**ITEM 12. DEVELOPMENT APPLICATION: 261-265 CHALMERS STREET
REDFERN - SOUTH SYDNEY LEAGUES CLUB**

FILE NO: D/2007/927

SUMMARY

Figure 5 – Level 3 Floor Plan Showing Location of New Floor Space & Areas Where Additional Floor Space has been Deleted from Proposal

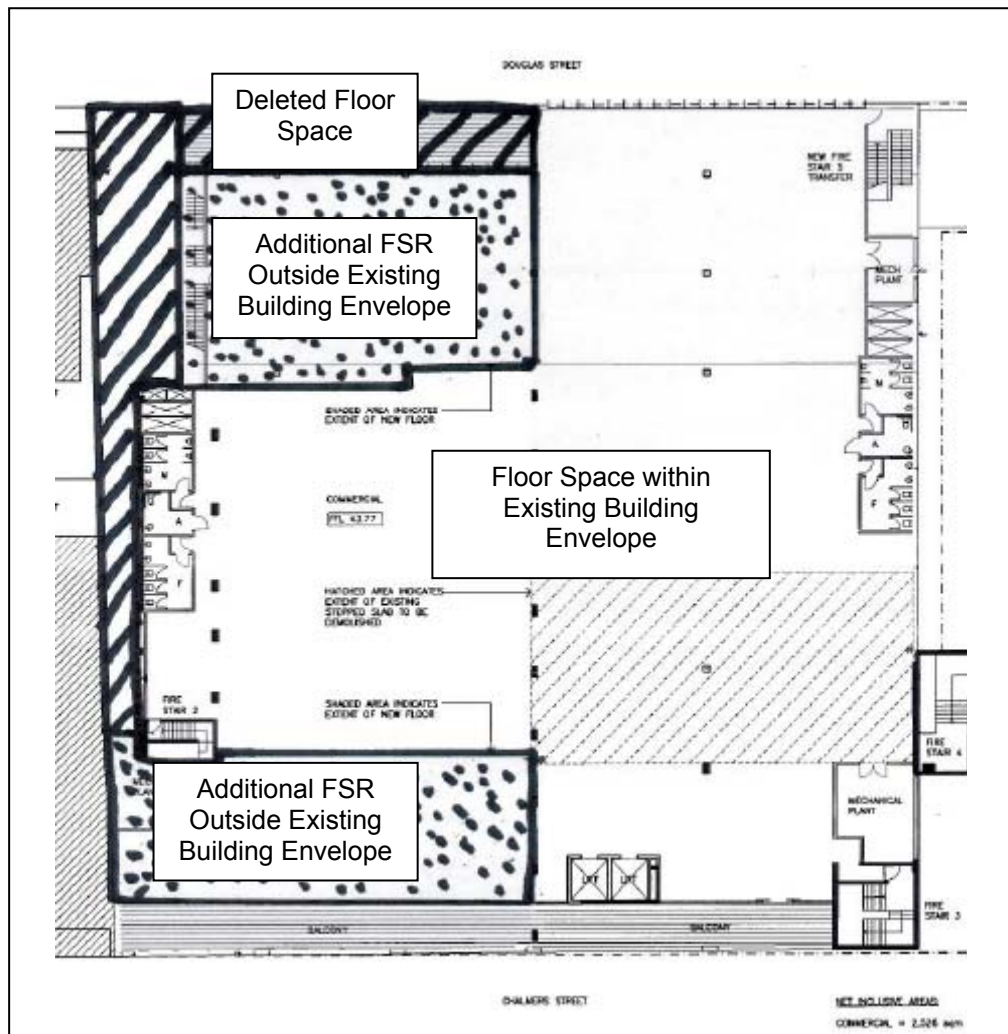
- (d) Level 3 – The works include relocating services and extending the existing building on the south west and north east corner, and upgrade office space. Level 3 proposes an additional 1,261sqm of floor space.

- (e) Level 3 has been reduced in size by 198sqm in the south west corner reducing the bulk of the development and reducing overshadowing.
 - (f) Level 4 has been reduced in size by 323sqm in the south west corner reducing the bulk of the development and reducing overshadowing.

Figure 6 – Level 4 Floor Plan Showing Location of New Floor Space & Areas Where Additional Floor Space

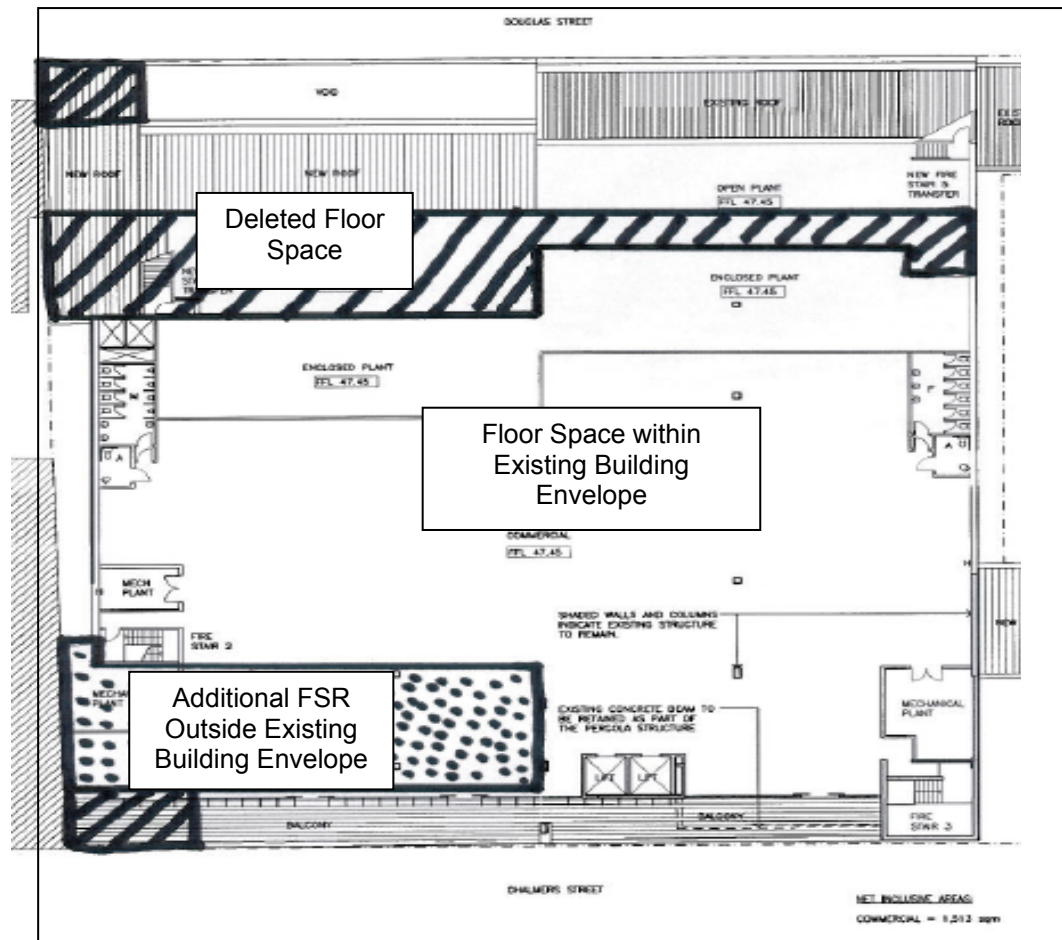
- (e) Level 4 – The works include infilling voids, upgrade of services and extending the existing building on the south west and north east corner, and upgrade office space. Level 4 proposes an additional 1,089sqm of floor space;

9am – 21 June Shadow

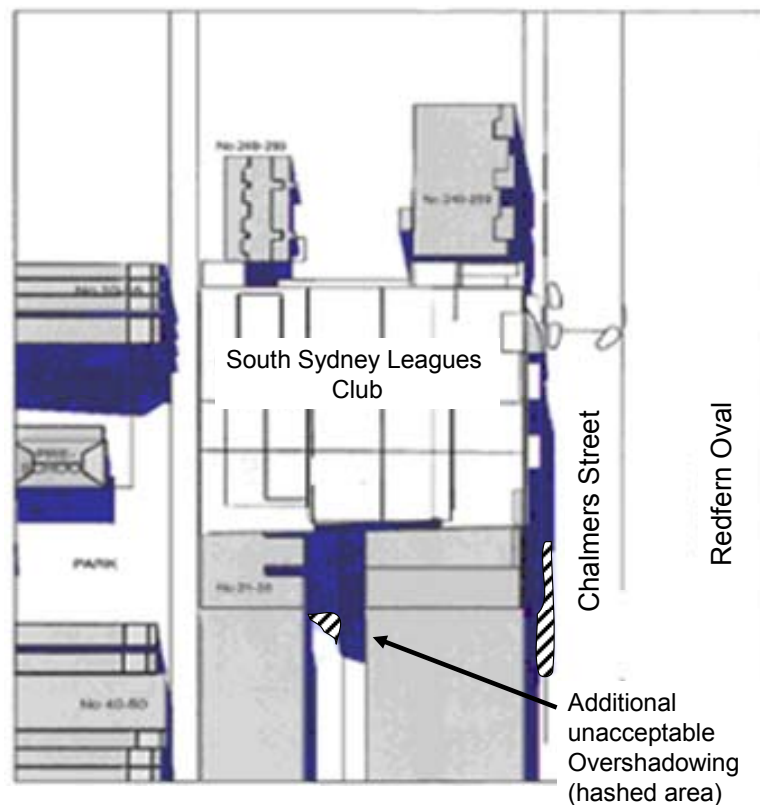
27. As can be seen, there is no increase in overshadowing from the proposed development at 9am.

12pm – 21 June Shadow

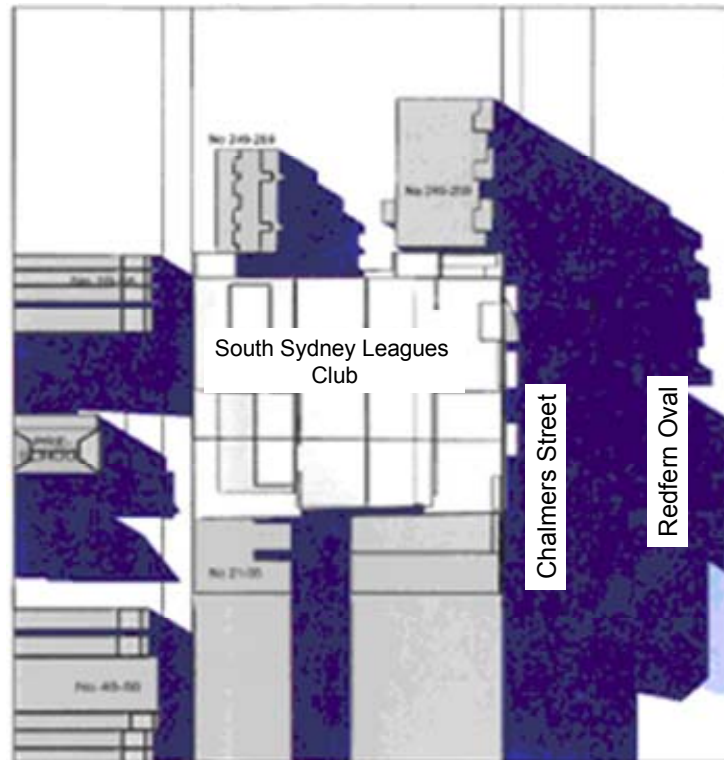
- 28. As can be seen there is additional overshadowing at 12pm, a portion occurs onto Chalmers Street and a section of rear yards on Chalmers Street & Douglas Street.
- 29. The overshadowing at 12pm onto the rear yards at Douglas Street and Chalmers Street is unacceptable. Whilst the impacts are only small, where a building exceeds the FSR control, this should not result in adverse impacts on adjoining properties in mid winter. Therefore a condition of consent has been included which will require the application to further reduce the building so there is no additional overshadowing.

- (a) The building is to be reduced in size so there is no additional overshadowing of adjoining properties on the 21 June. Detailed shadow diagrams are to be submitted at 9am, 12pm and 3pm on the 21 June, along with amended architectural plans.
